To: T10 Technical Committee
 From: Rob Elliott, Compaq Computer Corporation (Robert.Elliott@compaq.com)
 Date: 29 January 2001
 Subject: Minutes of the SRP WG – January 18-19, 2001 – Lake Buena Vista, FL

John Lohmeyer opened the SCSI over RDMA protocol meeting at 1:15 pm Thursday 18 January 2001 and thanked Adaptec for hosting. This protocol standard maps SCSI over InfiniBand™ Architecture, Virtual Interface (VI) Architecture, and similar transports supporting RDMA (remote direct memory access).

7. Proposed InfiniBand annex (01-028r1 by Greg Pellegrino and Rob Elliott)

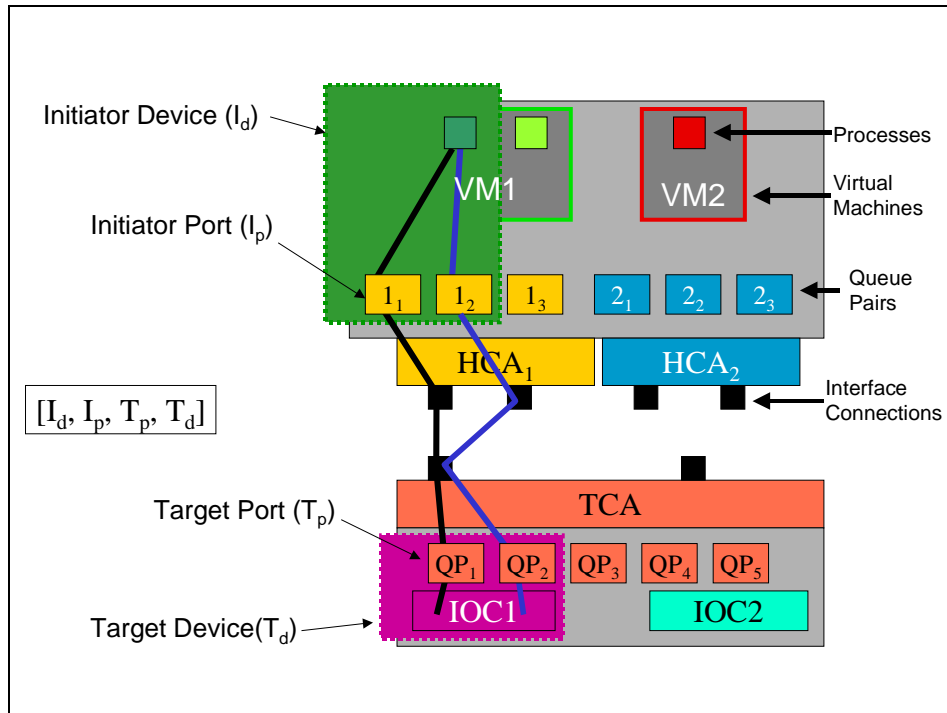
Cris Simpson provided a picture with processes, virtual machines, and queue pairs, showing the location of initiator port, initiator device, target port, and target device. This picture will be added to the annex to help future discussions.
